December 19, 2025

Michael Yarne  
BOV 1801 Tiburon, LLC  
2442 Valley Street  
Berkeley, CA 94702

On November 20, 2025, the Town of Tiburon received your Land Development Application on behalf of BOV 1801 Tiburon LLC. As described, the application proposes converting 17,720 square feet of an existing 87,120 square foot parking lot into nine fee-simple townhome units. The Tentative Map will subdivide the existing parcel (APN 059-161-012) into nine new residential lots, ranging from 1,840 square feet to 2,640 square feet. The subdivision will also create a 69,400 square foot, remainder parcel that will continue to serve as parking for the Point Tiburon Plaza commercial building.

Please be advised that the formal development application for the above project has been reviewed for completeness of application submittal requirements and has been found:

SHEET  
**A2.02**

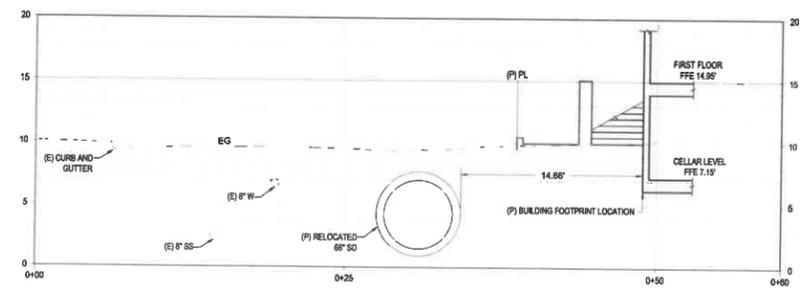
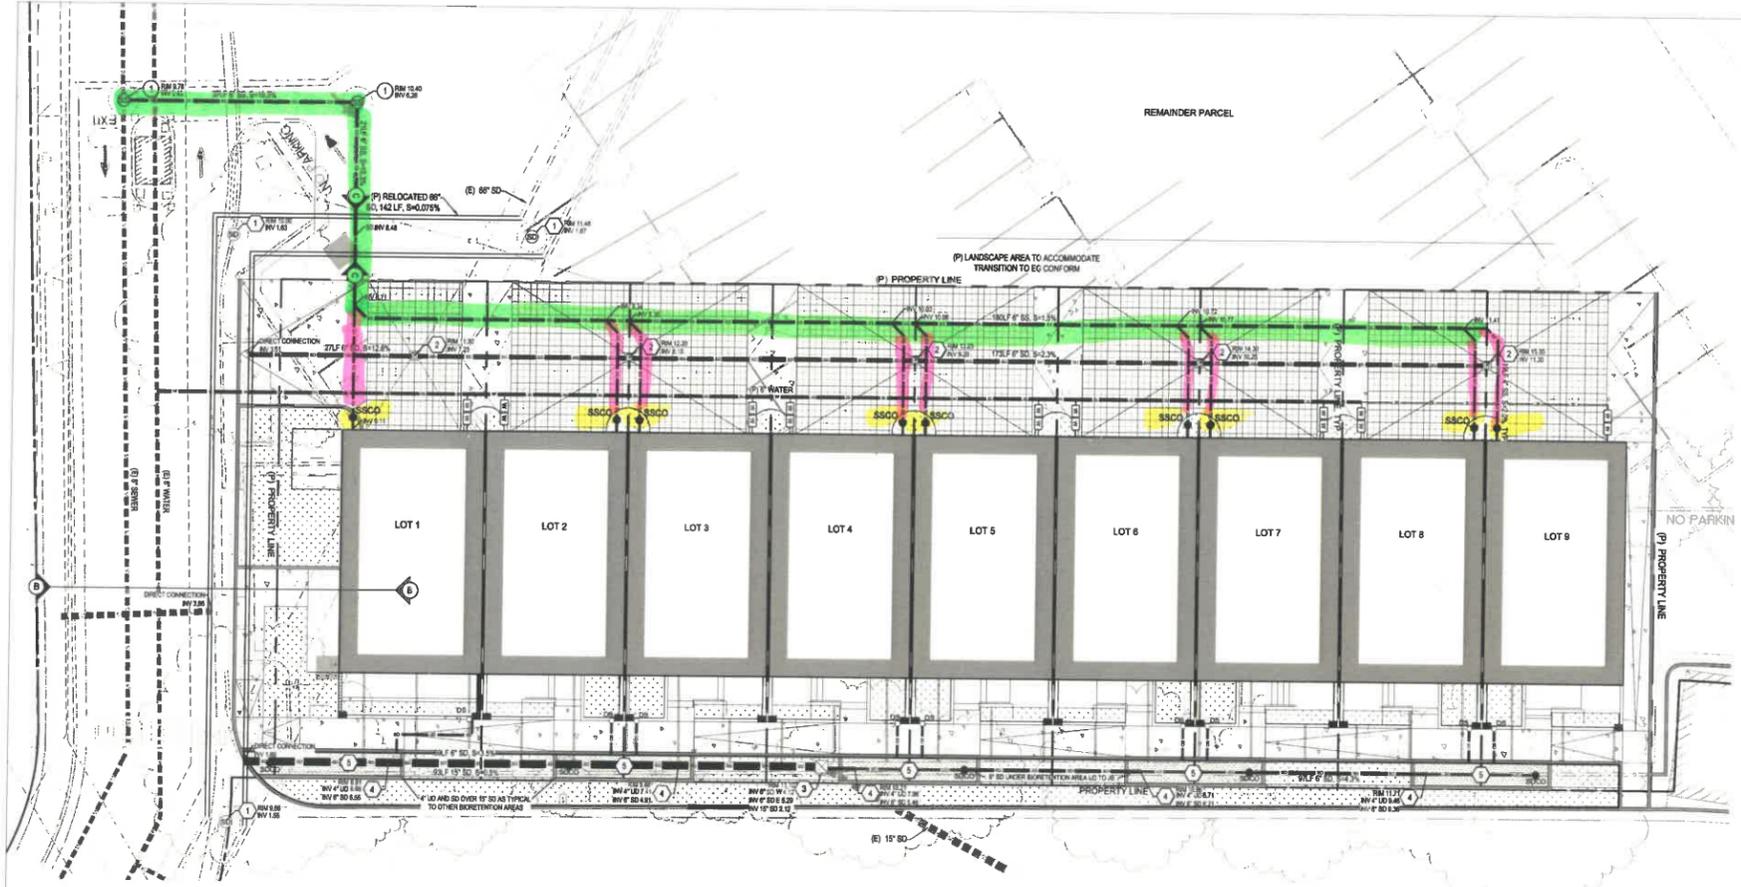
It also appears on various plans that the light sconces (L2) are proposed along the south elevation to light the front pathway, but it is not detailed as such. The elevations should identify if light sconces are proposed on the south elevation, or else they should be removed from the drawing. Please clarify.

A detail on the dimensions of the proposed skylight housing and cut-sheet specifications for the skylight and any proposed glazing and/or tinting is required.

Item 4 of the Elevations, Building Plans and Architectural Details of the Checklist requires a detailed roof plan. Item 8 of the Elevations, Building Plans and Architectural Details of the Checklist requires that the plans for each proposed building/structure show room labels, dimensions, square footage per level, doors, windows, interior walls. Item 9 of the Elevations, Building Plans and Architectural Details of the Checklist requires that the plans show cross-sections to show interior heights, roof lines and relation to finished grade.

The specified elevations of graded pads, floor levels, and all roof heights must be based on topographic datum provided in the Grading and Drainage Plan, to verify consistency with the elevations, preliminary grading plan and building height.
